# Access Compliance Report

## Public Rights-of-Way

### (Curb Ramps)

Intersection ID: 12897	Main Street: ABBEYDALE_DR	Cross Street: WOODGREEN_TR	Location: SW
ADA ID: 8A32E4CA3736	Ramp Type: Perp	Initial Pass/Fail: Fail	Overall Compliance: No
Severity Score: 8.75			
Codes/Mitigation Info/Possible Solution		Field Measurements/Component Compliance

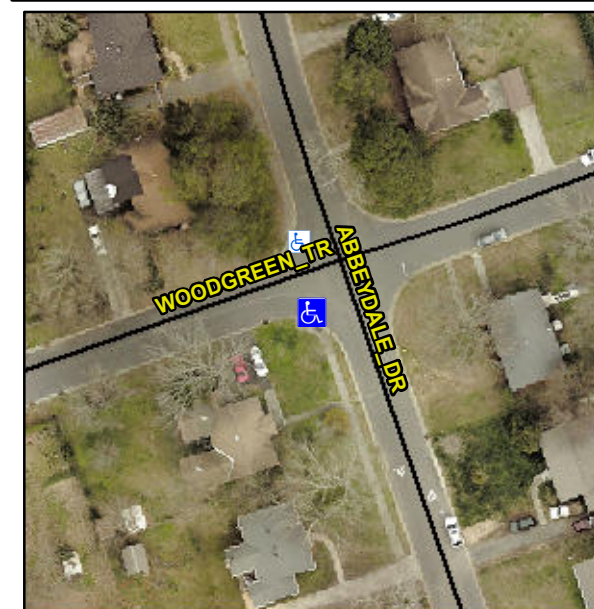
**Not Found, R304.5.1**

Compliance	Description	Data	Compliance	Description	Data
N/A	Ramp Length (in)	60.0	Yes	Ramp Slope (%)	5.2
No	Ramp Width (in)	43.0	Yes	Ramp XSlope (%)	0.9
N/A	Flare Type LT	N/A	N/A	Flare Type RT	N/A
N/A	Flare Slope LT (%)	N/A	N/A	Flare Slope RT (%)	N/A
N/A	Flare Traversable LT?	N/A	N/A	Flare Traversable RT?	N/A
N/A	Landing Length (in)	N/A	N/A	DWS Provided?	N/A
N/A	Landing Width (in)	N/A	N/A	DWS Contrast?	N/A
N/A	Landing Slope (%)	N/A	N/A	DWS Length (in)	N/A
N/A	Landing X Slope (%)	N/A	N/A	DWS Full Width?	N/A
N/A	Landing Curb? (Y/N)	N/A	N/A	DWS Offset (in)	N/A
N/A	Shared Landing?	N/A			
N/A	Gutter Ponding?	N/A	N/A	Gutter Slope (%)	N/A
N/A	Gutter Lip Ht (in)	N/A	N/A	Gutter X Slope (%)	N/A
N/A	Painted X Walk1?	No	N/A	Painted X Walk2?	N/A
	X Walk 1 Direction	To N		X Walk 2 Direction	N/A
N/A	X Walk 1 Width (in)	N/A	N/A	X Walk 2 Width (in)	N/A
	X Walk 1 Slope (%)	4.3		X Walk 2 Slope (%)	N/A
	X Walk 1 X Slope (%)	5.8		X Walk 2 X Slope (%)	N/A

**Remove & Replace Entire Ramp.**
